NEW MEXICO OIL CONSERVATION DIVISION

ADMINISTRATIVE APPLICATION COVERSHEET RECEIVED OCL

Administrative Approval of Unorthodox Location-Sidetrack

San Juan 32-5 # 111Well

WELL LOCATION AND ACREAGE DEDICATION PLAT

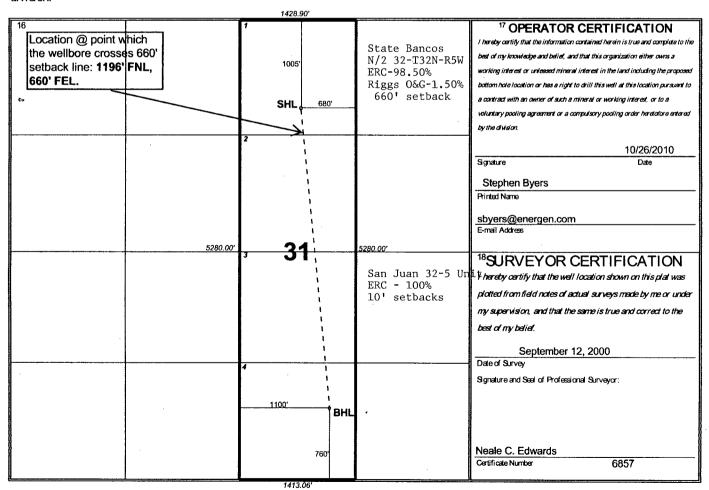
- 1. The C-102 indicates a 160-acre unit. This would be non-standard for the Fruitland which is spaced on 320 acre units. I assume this is an irregular section. If it is an existing non-standard unit created by a hearing order or administrative non-standard unit (NSP) order, I need a reference to the applicable order. Otherwise a non-standard unit application is required.
- 2. The application does not state the footage location of the "penetration point" *i.e.* the point where the wellbore intersects the top of the Fruitland formation.

This is a NSP approved on August 22, 2001 as Administrative Order NSP-1847 and is a 345.59 acre spacing unit. The penetration point into the top of the coal is 1187' FNL and 661' FEL. In Section 31-T32N-R5W.
